CPRM, October 31, 2023 PL-59-23 Correspondence from MHBC

# RE: COMMENTS ON DRAFT COMMUNITY PLANNING PERMIT BY-LAW AND OFFICIAL PLAN AMENDMENT NO. 2

OUR FILE 22173A

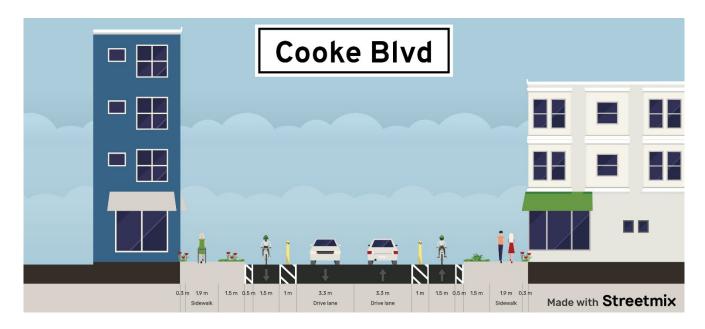
The current width of Cooke Boulevard is approximately 20 metres.

The 2020 Official Plan (OP) does not illustrate Cooke Blvd as a connector or collector road. The inclusion of active transportation facilities and complete streets on Cooke Blvd is supported; however, a 30m ROW is not necessary and in appropriate in an area that is promoting intensification and an animated streetscape.

That being said, the following Illustration demonstrates how a 20 metre ROW can accommodate active transportation infrastructure, including space for curbs and 0.30 m buffers from the property lines. The Cycle Track sketch illustrates the minimum requirements set out in the By-Law amendment and OTM, with extra space on the outside of the 1.5m buffers. It is noted that the sketch assumes that a two-way left-turn lane (TWLTL) will not be added to Cooke Blvd and the existing "No Parking" restrictions remain.

**Recommendation**: Maintain Cooke Boulevard as a 20 m ROW, which can accommodate such active transportation infrastructure (as illustrated below).
